## **BID ADDENDUM #1**

**Nanuet Union Free School District**  
**103 Church Street**  
**Nanuet, NY 10954**

***Nanuet Bond Projects Phase 4***

**Date: March 19, 2024**

**HS-AD111**

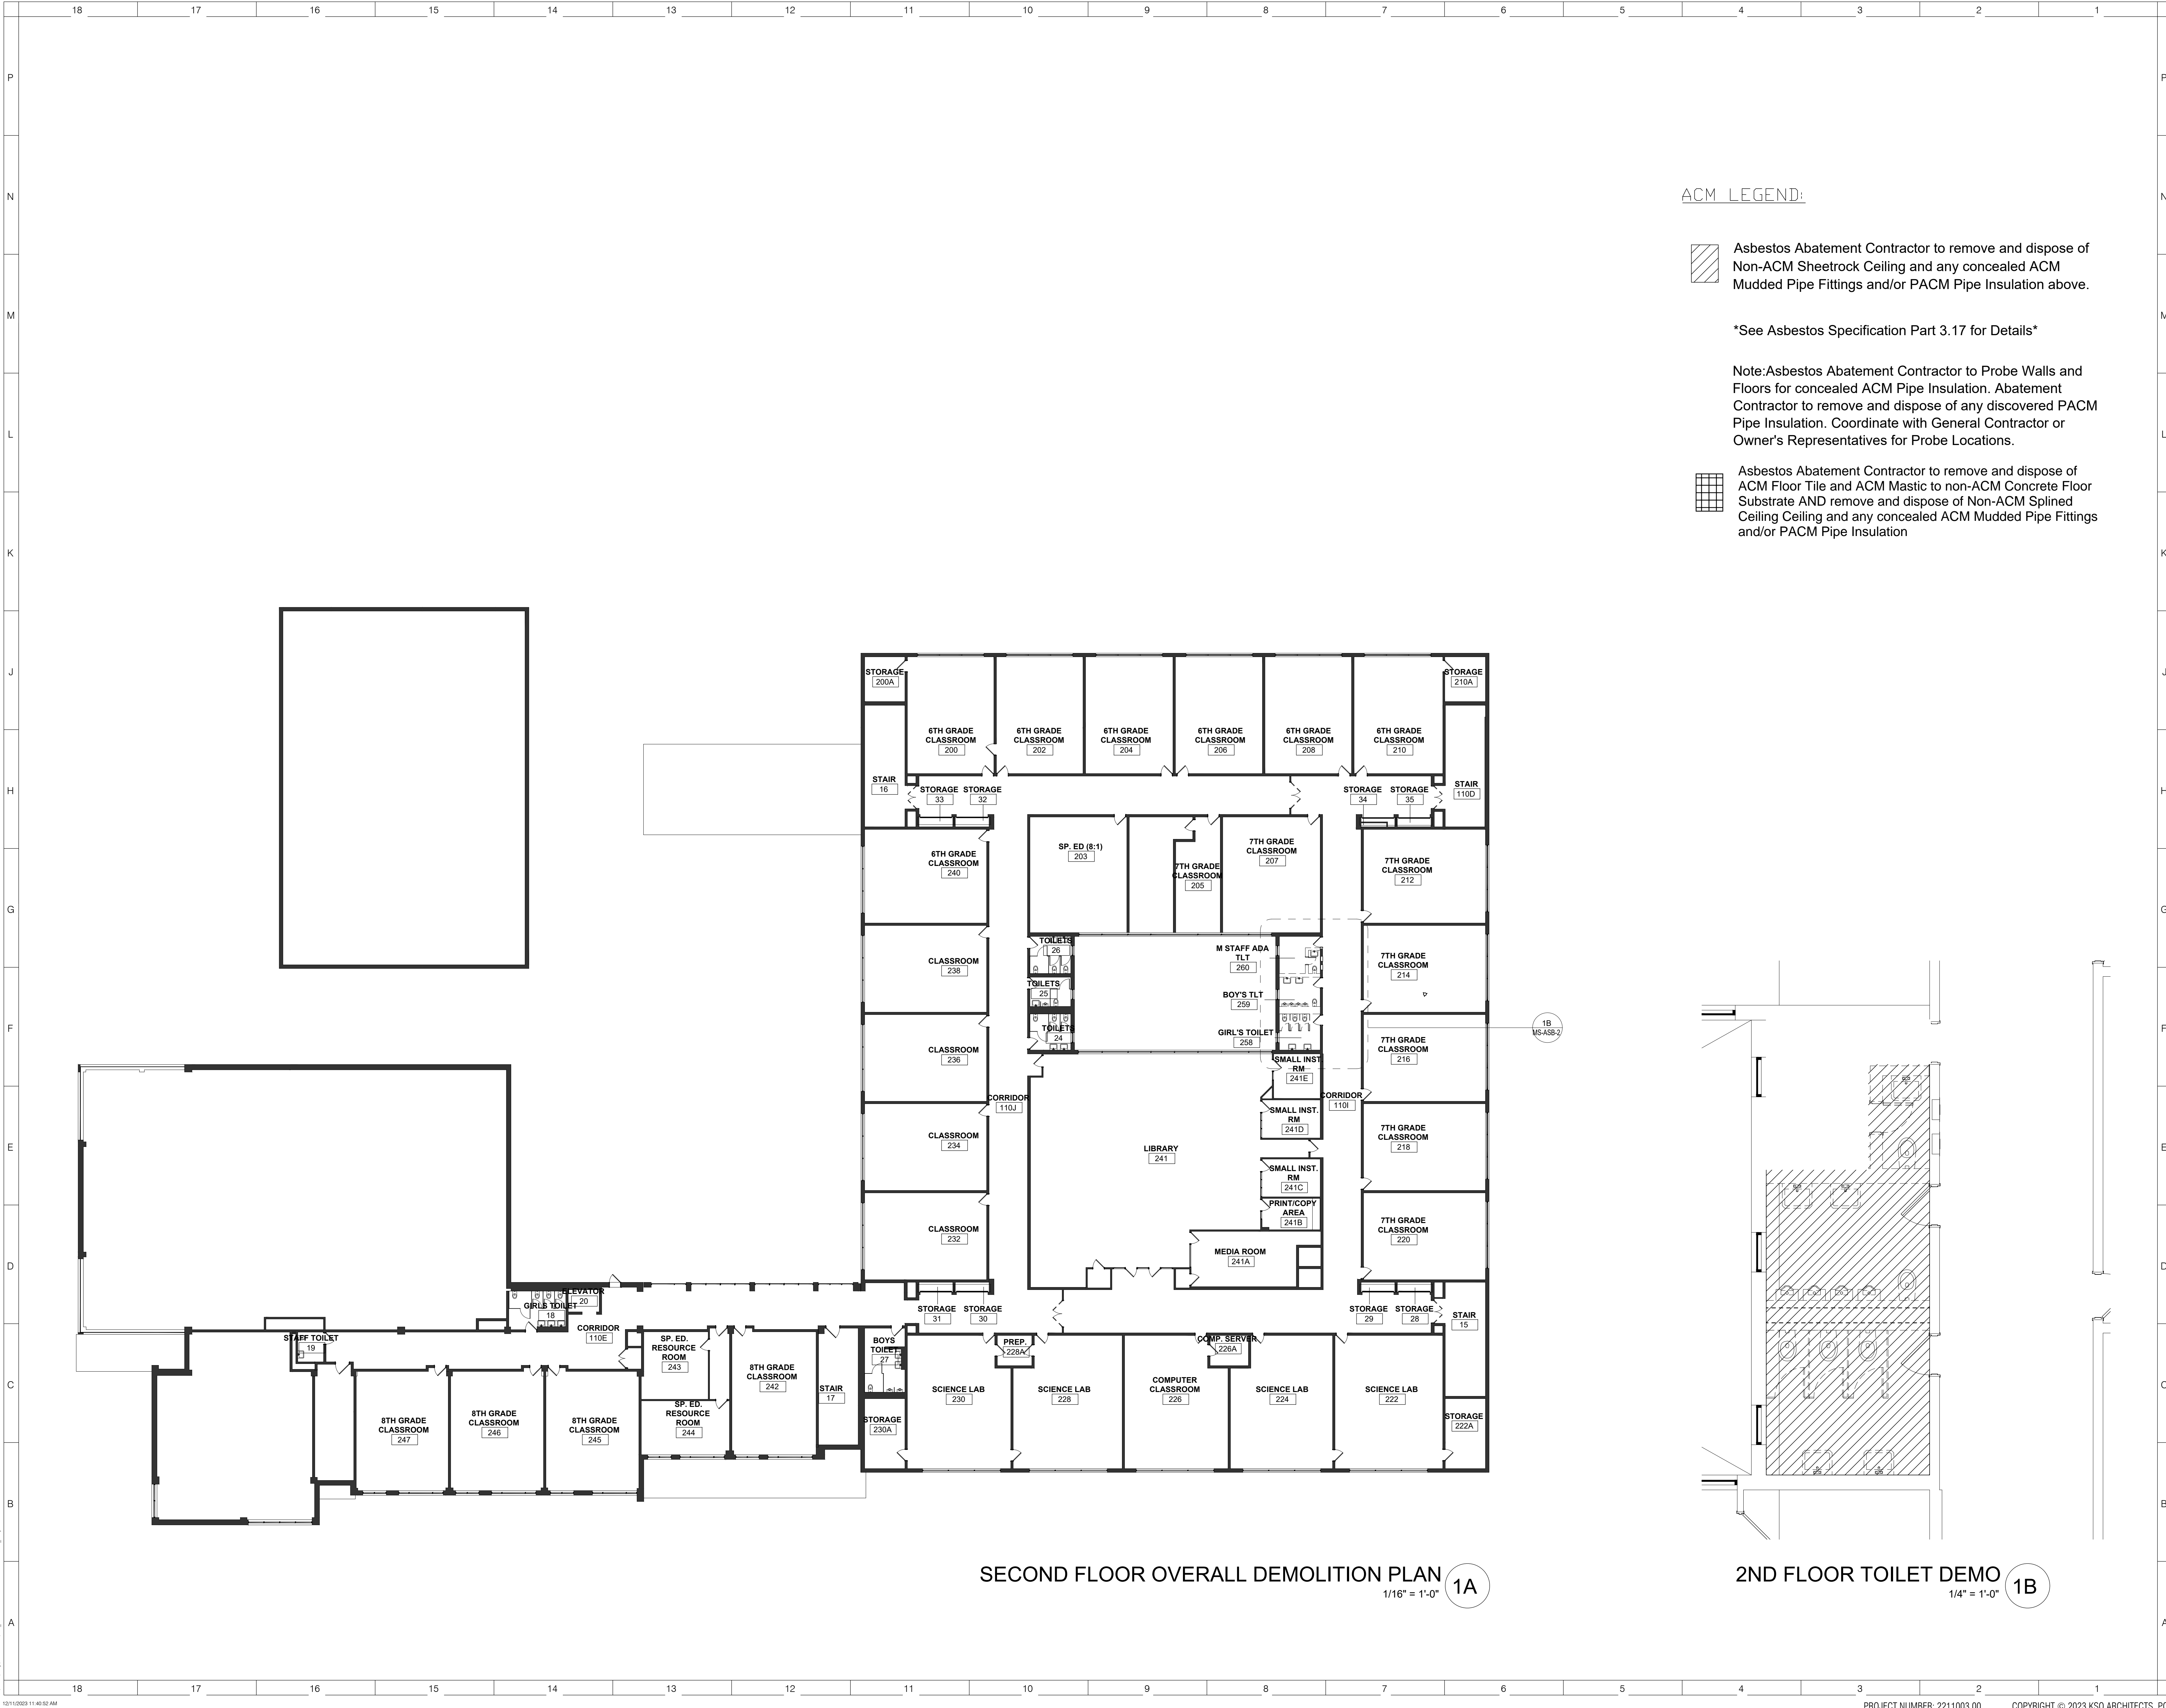
1. **Sheet HS-AD11: FIRST FLOOR OVERALL RCP DEMOLITION**
  - A. Updated hatch to indicate removal of plaster ceiling above suspended ACT ceiling is required for mechanical work in the Super Intendent Office and Conference Room. See attached drawing.
